NUMBER: 18-101-22 REV. A

Flash: Powertrain Control Module (PCM) Updates

2019	(DJ)	RAM 2500 Pickup
2019	(D2)	RAM 3500 Pickup

NOTE: This bulletin applies to vehicles equipped with a 6.7L I6 Cummins Turbo Diesel Engine (Sales Code ETL) or 6.7L I6 Cummins HO Turbo Diesel Engine (Sales Code ETM).

Fig. 1
CP3.3 Design Pump

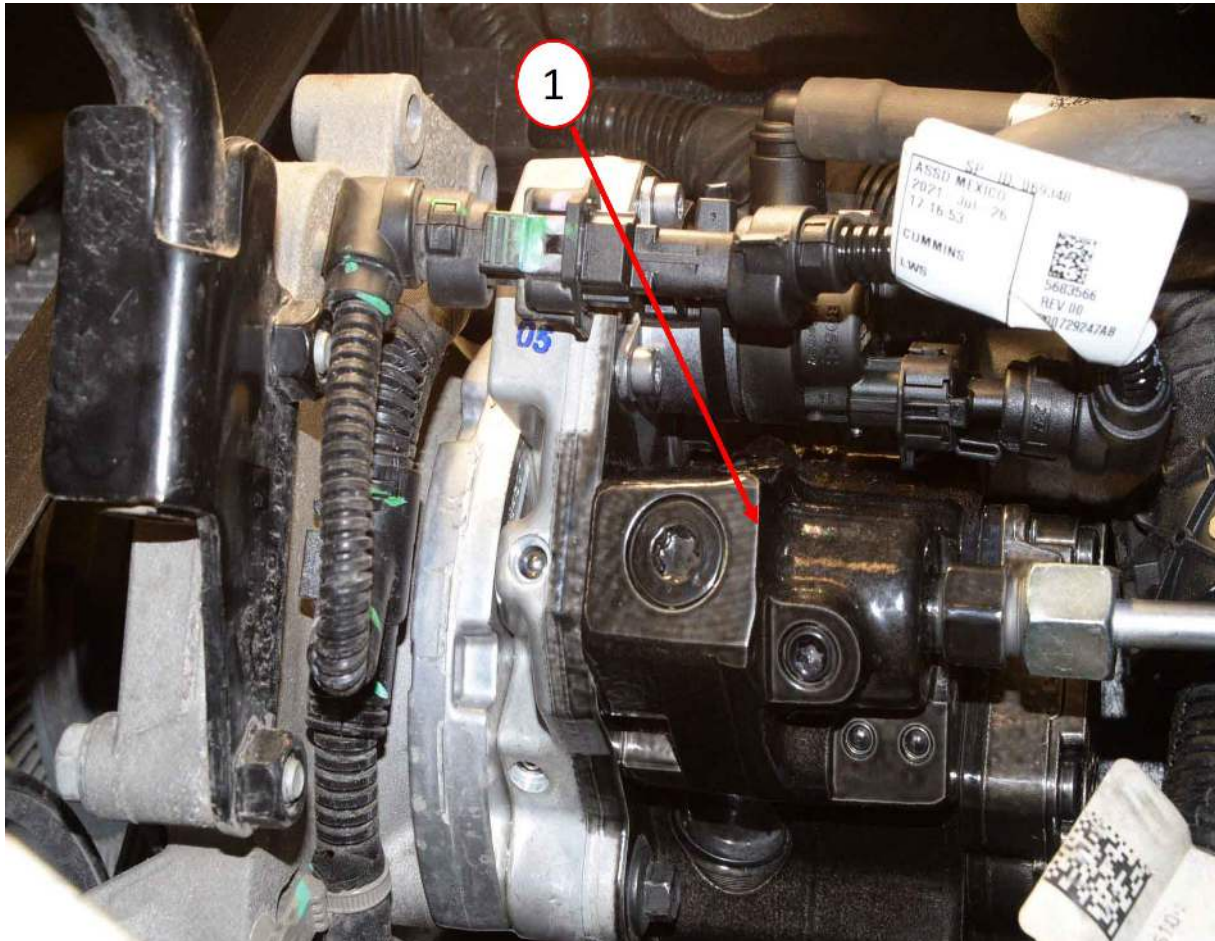
NOTE: The only calibration available will be for the updated CP3.3 design High-Pressure Fuel Injection Pump ([Fig. 1](#)) . Please ensure that recall Y78 has been completed first before proceeding with this update.

1. Inspect the High-Pressure Fuel Injection Pump to see which pump is currently installed on the vehicle ([Fig. 1](#)) . Also review the vehicle VIP report to see if campaign Y78 has been performed.

2. Does the VIP report indicate that Y78 has been performed, and is the vehicle equipped with the new design fuel injection pump released under the campaign?
 - YES>>> Proceed to [Step 1](#).
 - NO>>> Perform the Y78 campaign first. Once the campaign is performed, new pump installed and PCM updated, the PCM will have all of the updates listed in this document. This Bulletin does not apply.
